9860 & 9854 - 90 Avenue NW and 9013 & 9009 - 99 Street NW

To allow for a mid-rise mixed use building.

Recommendation: That Charter Bylaw 20223 to amend the Zoning Bylaw from (DC2) Site Specific Development Control Provision to (DC2) Site Specific Development Control Provision be **APPROVED**.

Track Changes of Proposed DC2 Against Current DC2.1135

Proposed DC2 - Site Plan

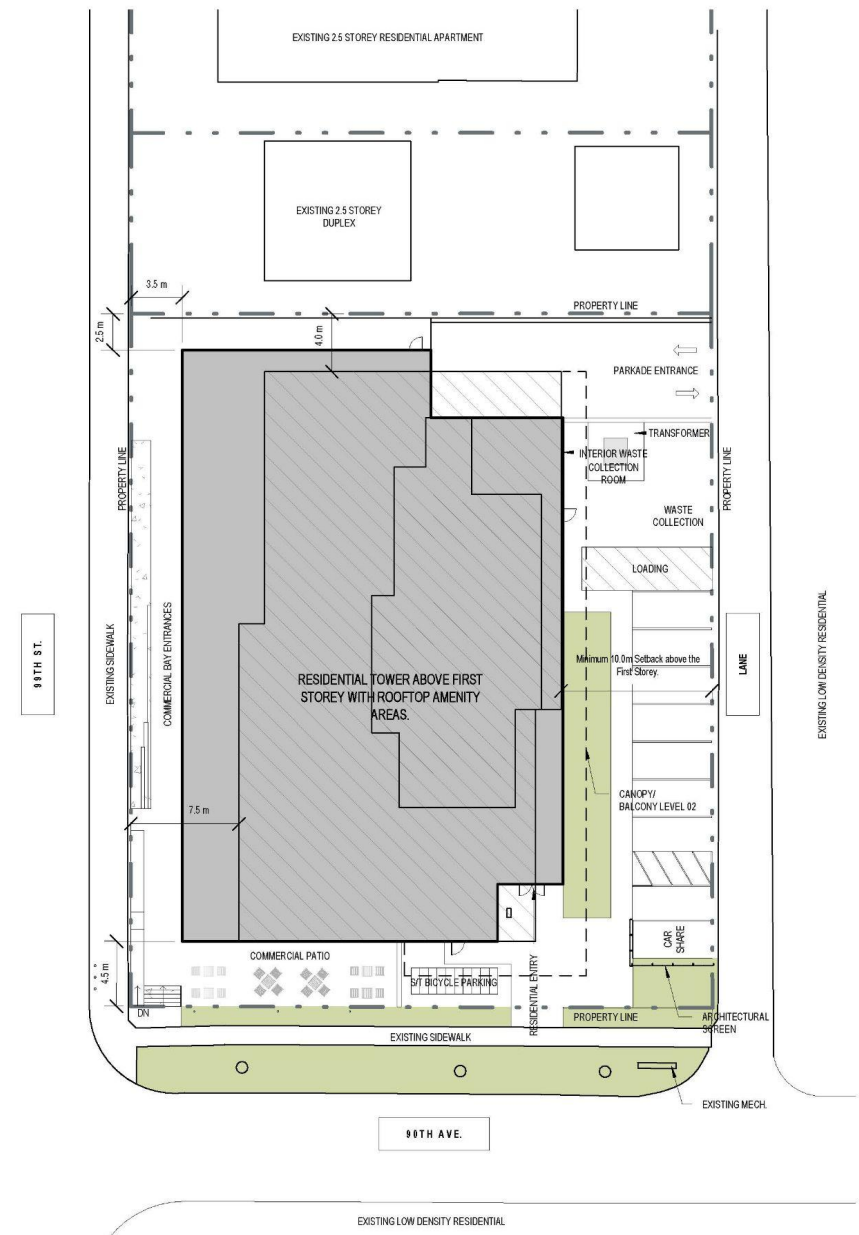
Deleted provision to reflect the removed tandem space proposed in the DC2 Site plan appendix.

Proposed DC2 - Landscape Concept

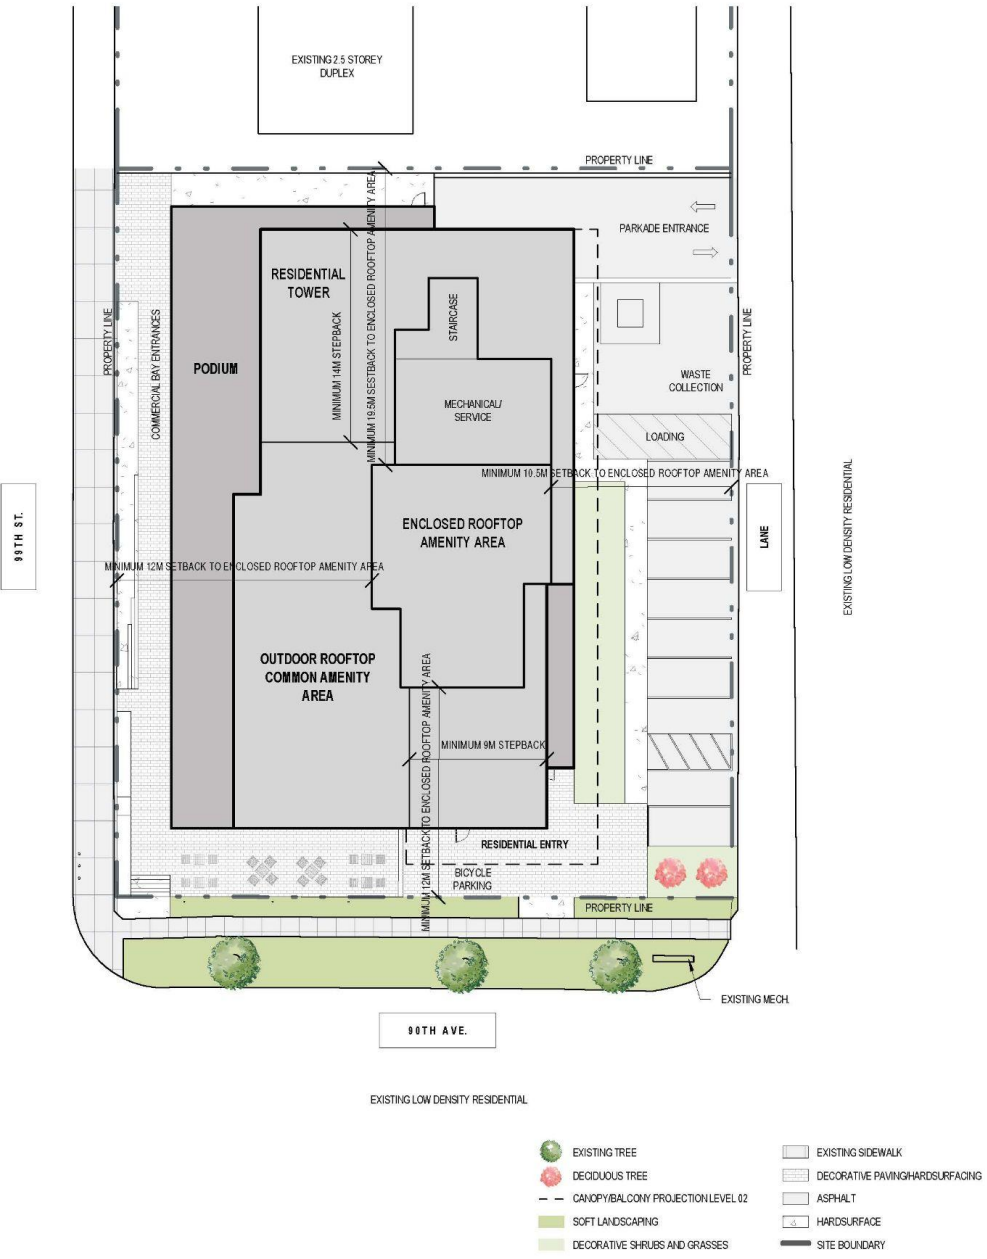
Requires planters and retaining walls to incorporate decorative surfaces to avoid a monolithic appearance.
